RE: USPS Master Plan/Broadway Corridor Project

CASE FILE: 2019-246279 CCMP AD -
USPS Broadway Corridor Master Plan
PC # 19-147103

Re: Case file : LU 19-246279 CCMP AD – USPS Broadway Corridor Master Plan
PC # 19-147103

Re: LU 19-246279 CCMP AD

Height Comparison

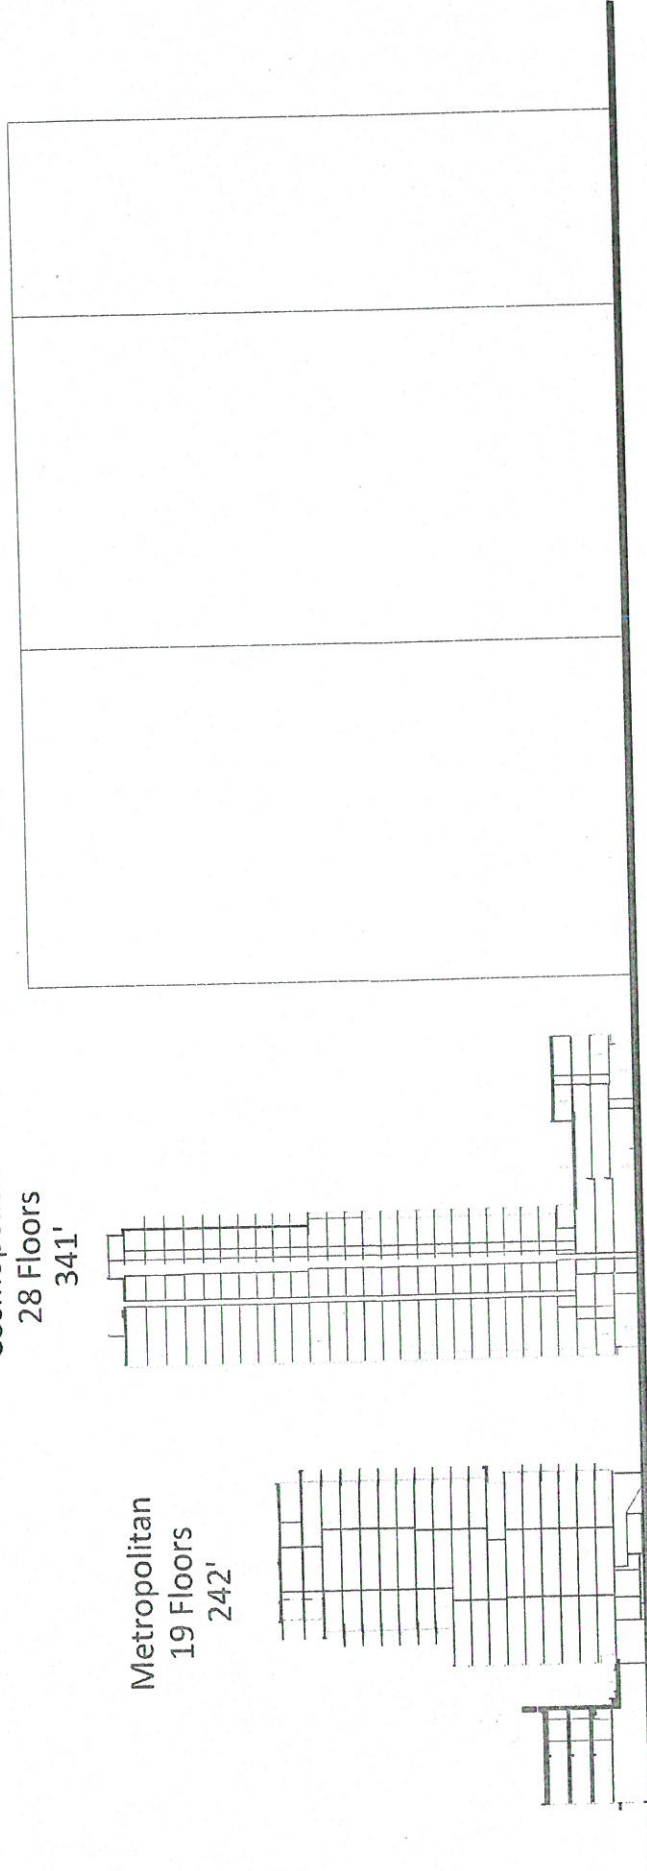
We contend that the 400' tall buildings shown on blocks 6, 9A, 9B and 9C will cast shade on Jamison Square, which is located one block to the west, during spring, summer, and autumn months when the sun rises to the east and northeast of the project site. This will have a detrimental effect on the park in that both vegetation and human users will be impacted by the lack of sun. Benches along the eastern border, which were designed so that one could sit and enjoy the morning sun, will be in shade until midday. The wooden boardwalk which usually dries quickly in the morning, will remain wet and slippery longer and likely deteriorate sooner. Vegetation designed for day long sun will suffer. A park area that is a beloved, because it is sunny, will become a dark canyon.

We urge you to consider the negative impact that this proposed project will have on one of Portland's successful districts. The 400' tall buildings are too close to this residential area and more suitable to downtown.
